Product Change Notification / GBNG-16RJZN641

CCB 4279.001 Final Notice: Qualification of GTK as a new assembly site for selected SST38VF640xx, SST39LF40xx and SST39VF40xx device families available in 48L TSOP (12x20mm) package.

CCB 4279.001
Pre and Post Change Summary
PCN #: GBNG-16RJZN641

LPI

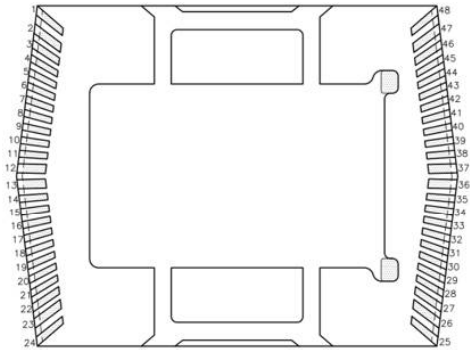
Paddle size	162 x 260 mils
-------------	----------------

GTK

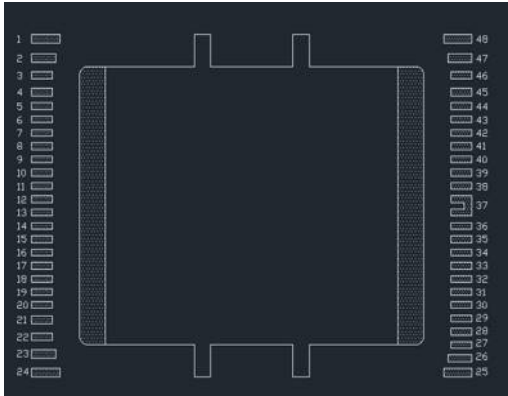
Paddle size	330 x 260 mils
-------------	----------------

LPI

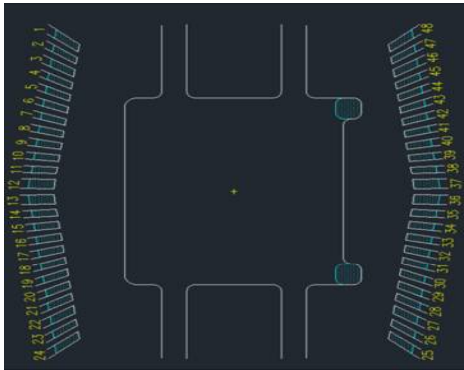
Paddle size

160x130 mils

GTK

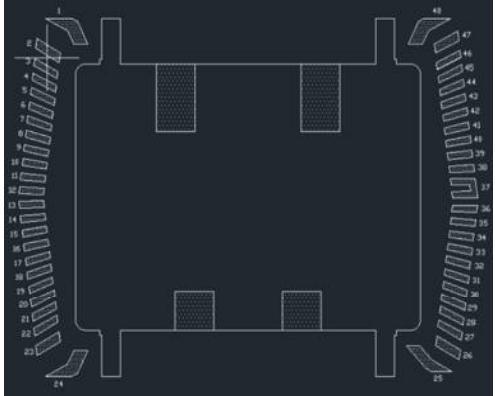
Paddle size

280 x 210 mils
